Guelph/Eramosa Township Hydrogeology Agency Review Document Book

Hydrogeology Review Document Book Index

Re: Harden Response Letter Dated June 12, 2015
Project No.: 300032475.0000

**Re: JDCL Response to Hunter and Associates May 15, 2015 Peer Review
Project No.: 300032745.0000**

Fig 1.1A

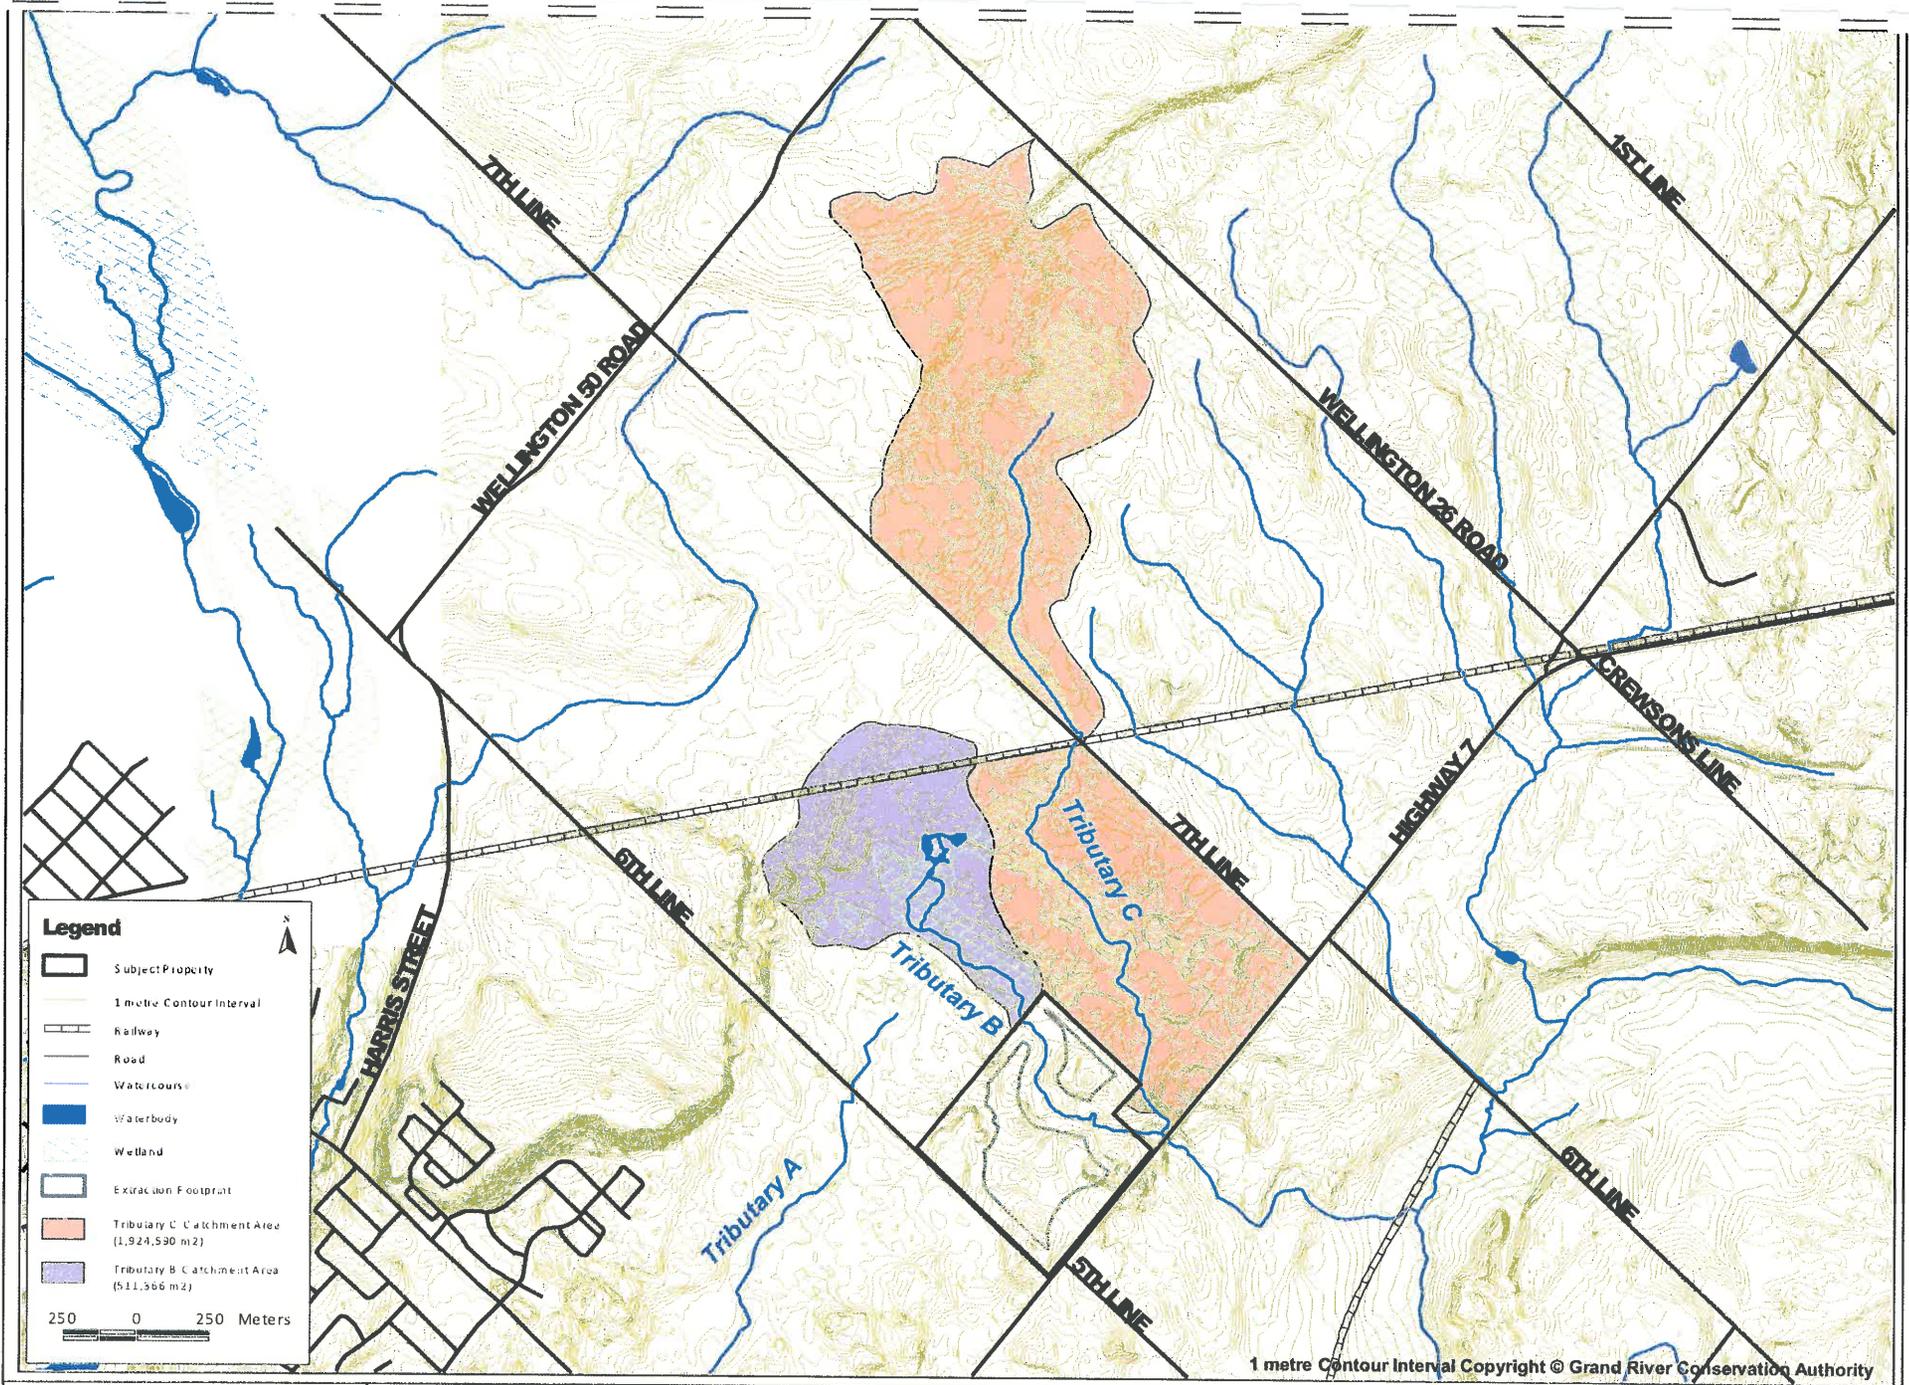
In addition, potential extraction within the 165 m receptor R16 setback limits will encroach on the 400 m buffer distance and have adverse implications for Brydson Creek Brook Trout spawning areas (Fig 1.1A). It is unclear from the Site Plan if the 165 m Blasting Impact Analysis line is the true extraction limit. The Site Plans (pg 3) state

The 250 m encroachment distances need to be shown on the Site Plan together with the note below. Site Plan notes should state what these special precautions might be (see also Golder October 1, 2014 and Hill January 31, 2015) (Fig 1.1A).

- Fig 1.1A** Various Blasting and other Buffer Zone distances contained in the Applicant documents and Peer Reviews have been superimposed on the Hunter Hidden Quarry base mapping. Domestic well sites included. The spring fed pond at the Brydson Creek headwater is 225 m from the licence limit, 350 m distant from the overburden extraction limit and 425 m from the bedrock extraction limit. Bedrock extraction into the 165 m R16 (W19) receptor setback limit as implied on the Site Plans will reduce the buffer limit from the Brydson Creek headwater.

Fig 1.2

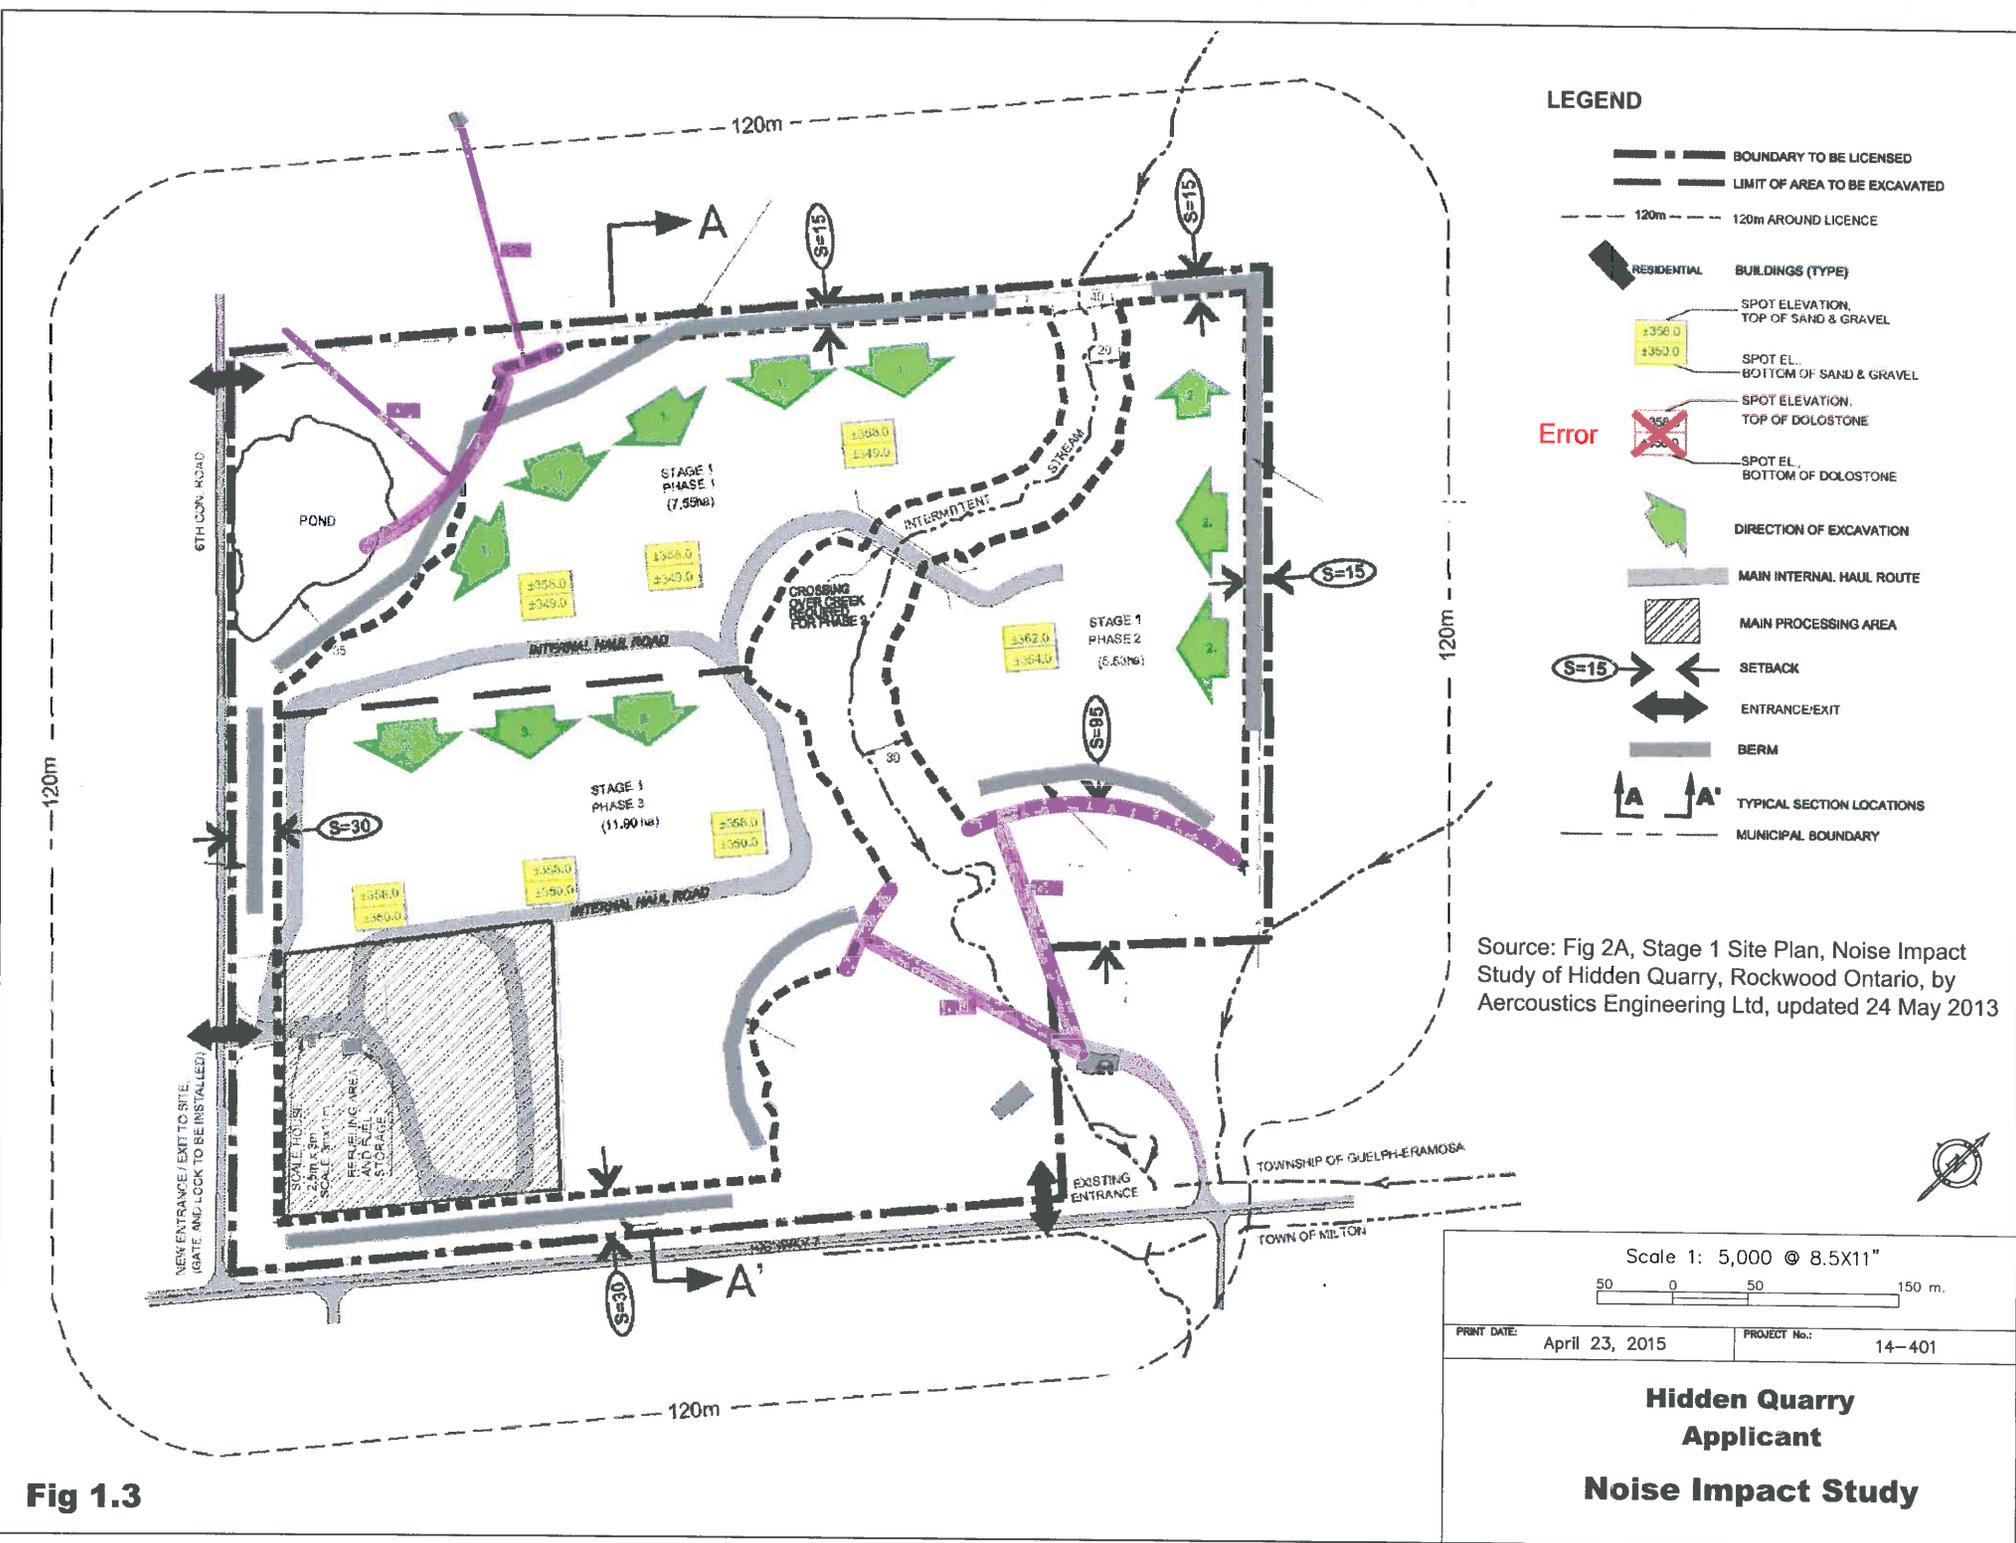
- Fig 1.2** Fig 1.2 shows the direction of extraction (excavation) and Blasting Limit lines as recommended by the Applicant Blasting Study. The Site Plan Note contradicts the Blasting Line Limit (165 m) diagram.

Fig 1.4A

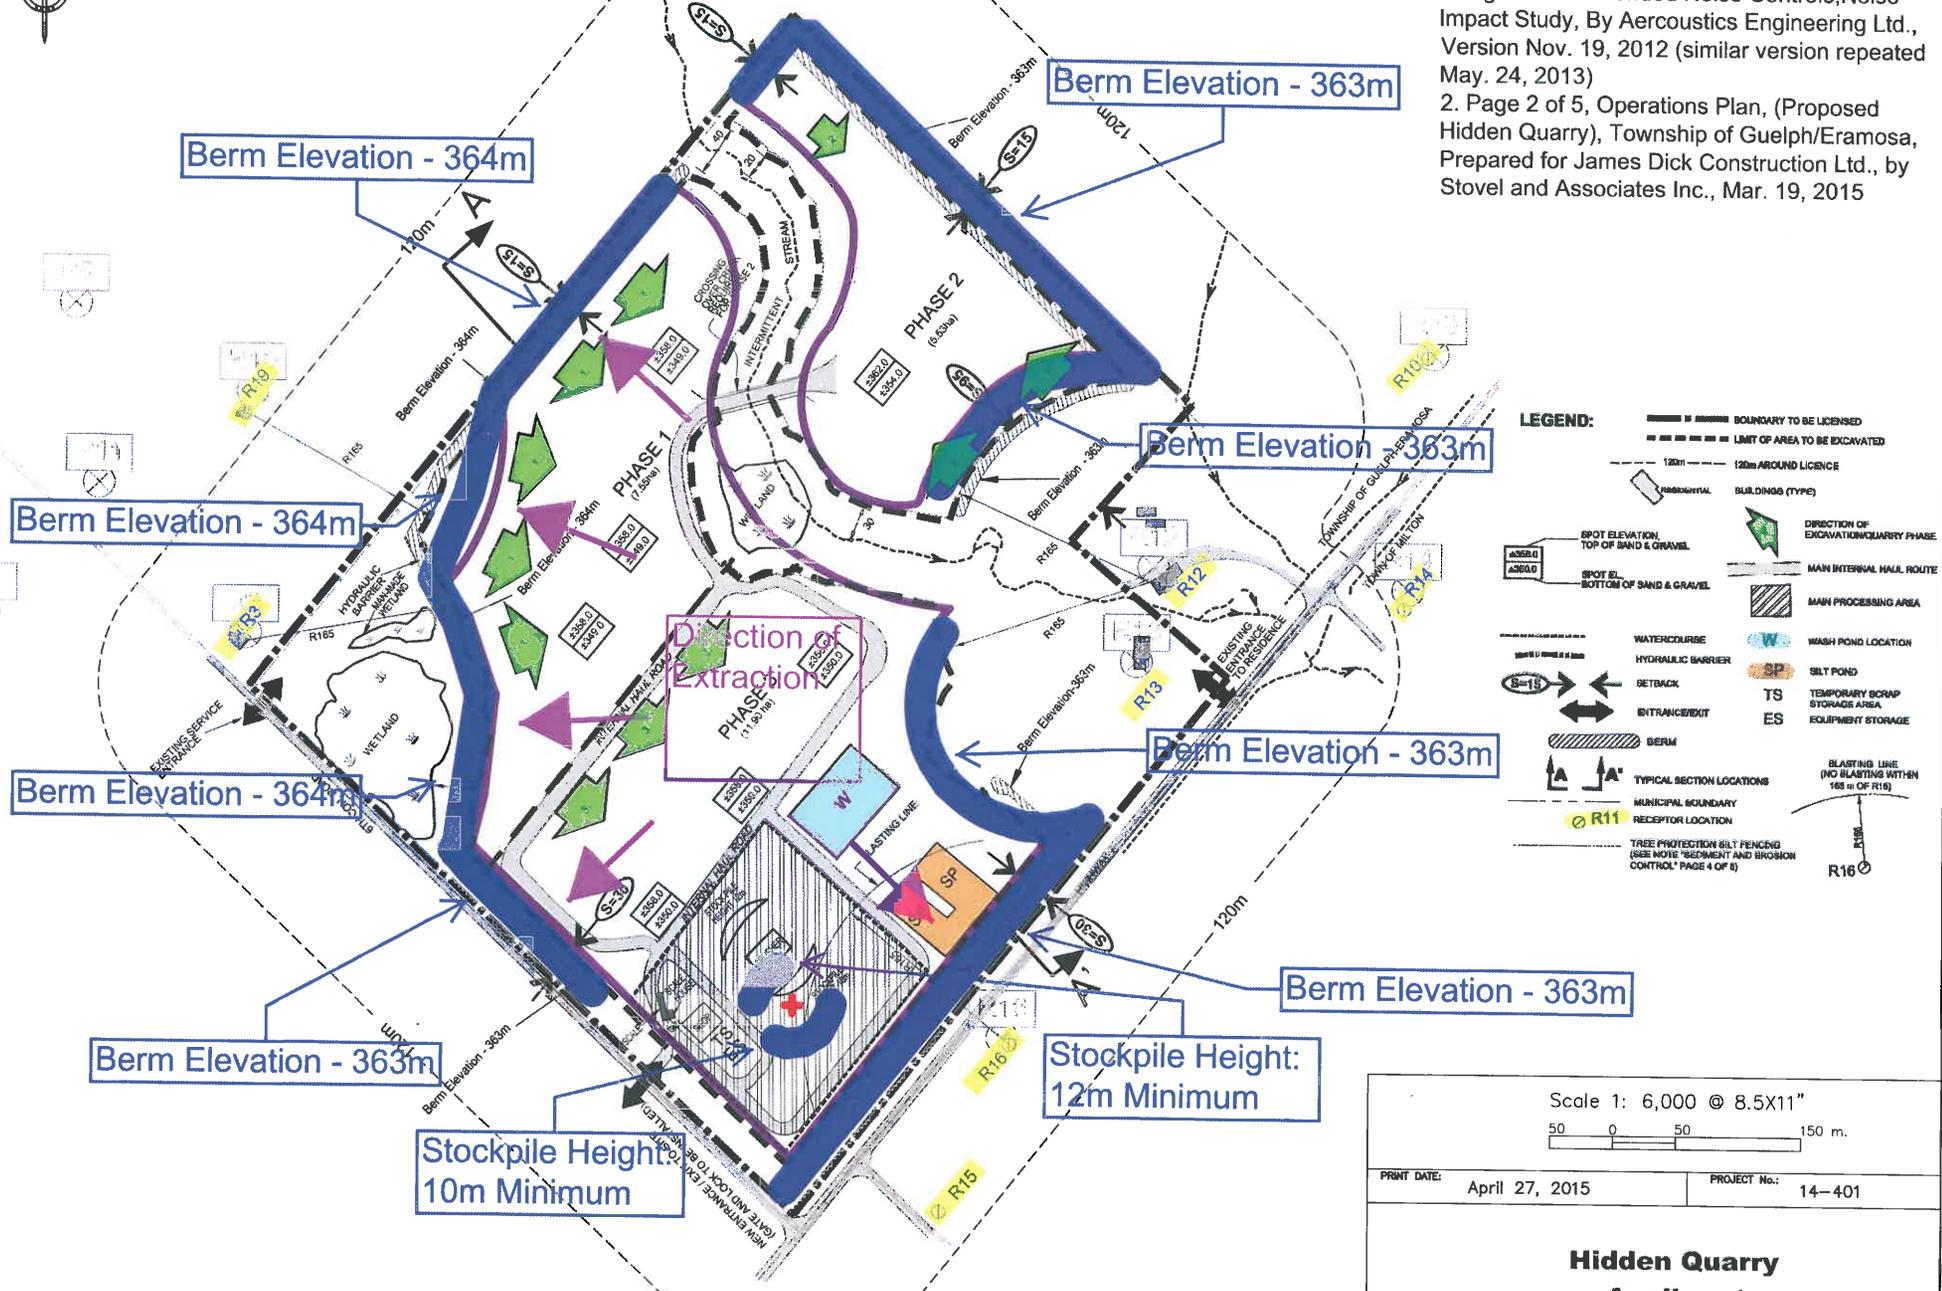
- Fig 1.4A** Fig 1.4A shows the contradictory directions of extraction in the Applicant's Noise Study compared to preceding Fig 1.2 and 1.3. Fig 1.4A appears to be the authority for the Site Plan top of acoustical berm elevations.

Fig 1.5

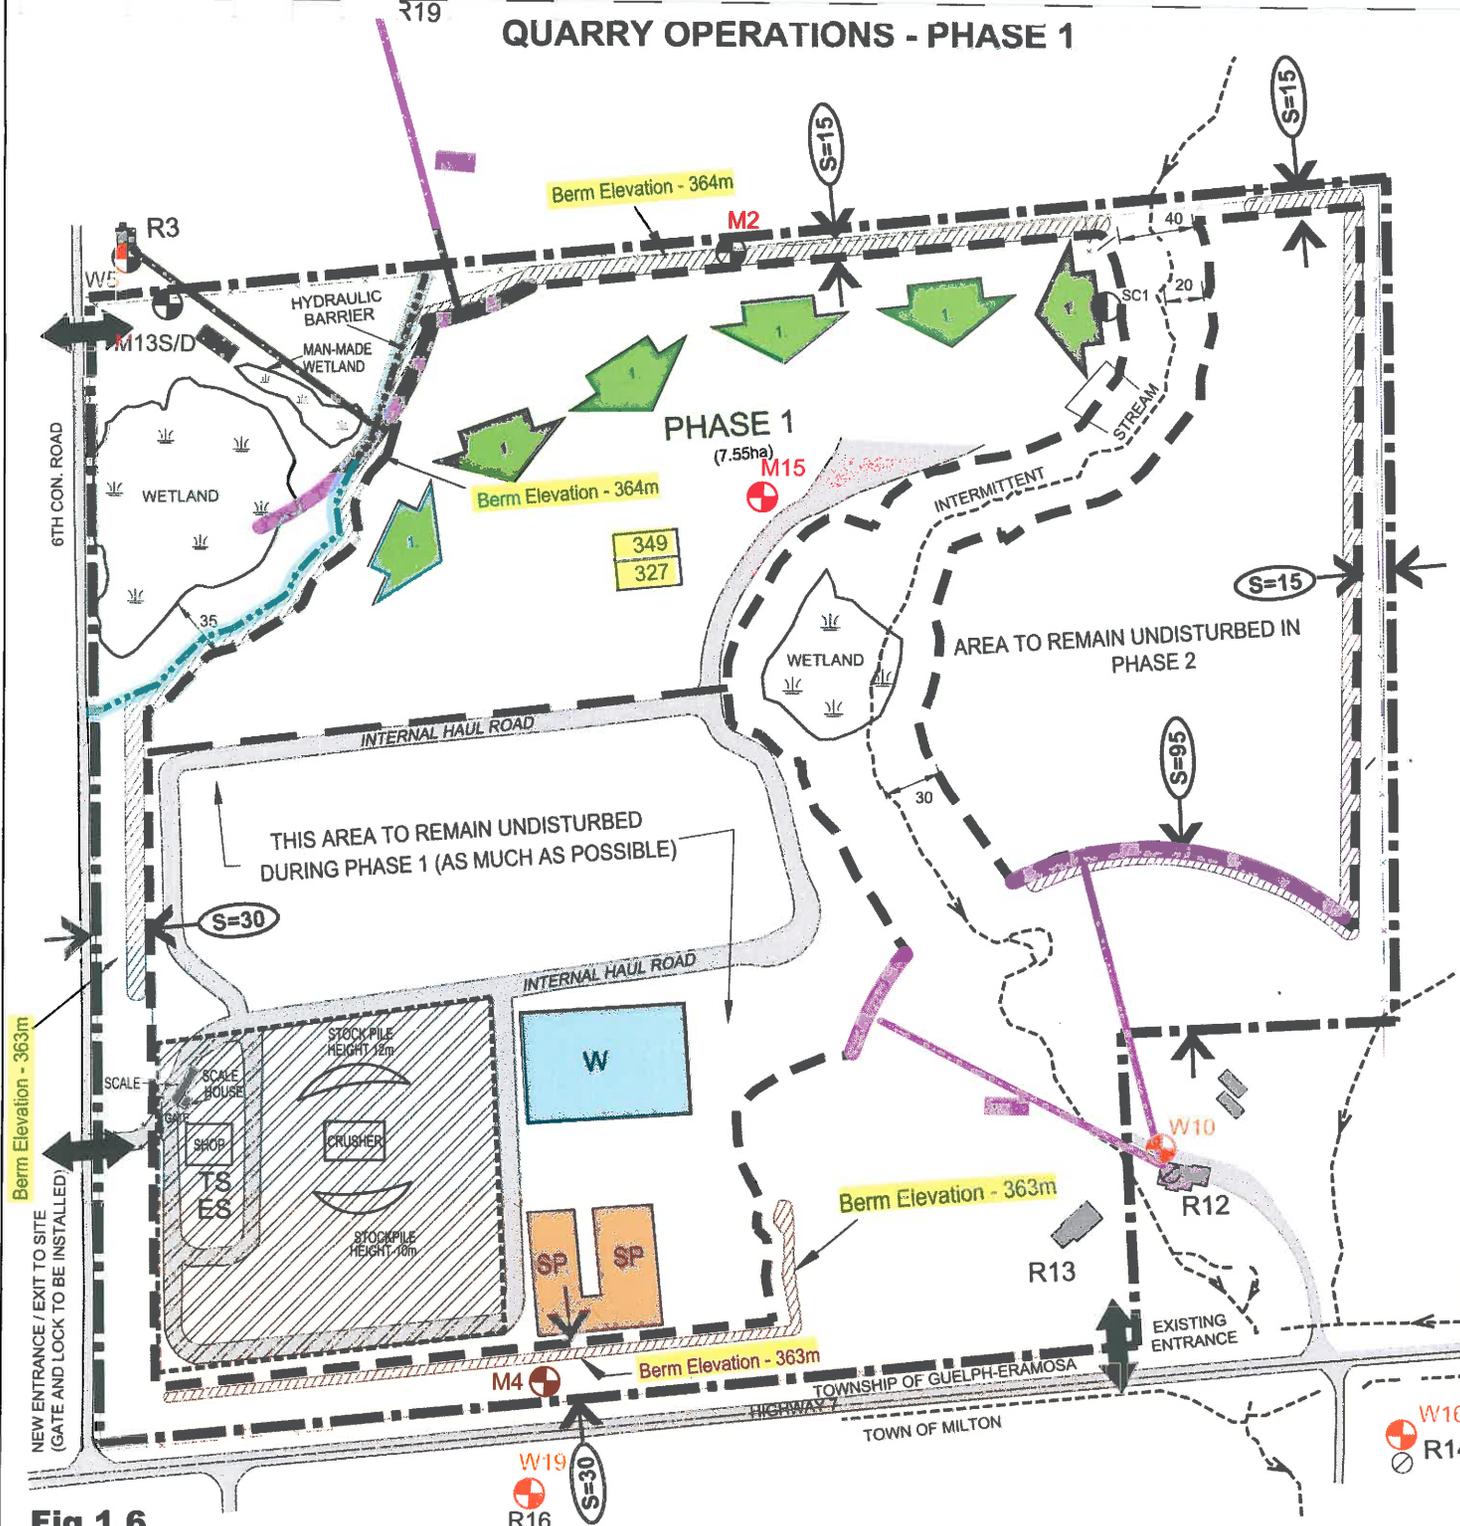
- Fig 1.4B** Fig 1.4B shows the contradictory directions of extraction on the superimposed Applicant Site Plans vs the Noise and Blasting Studies as shown on Fig 1.2, 1.3 and 1.4A.
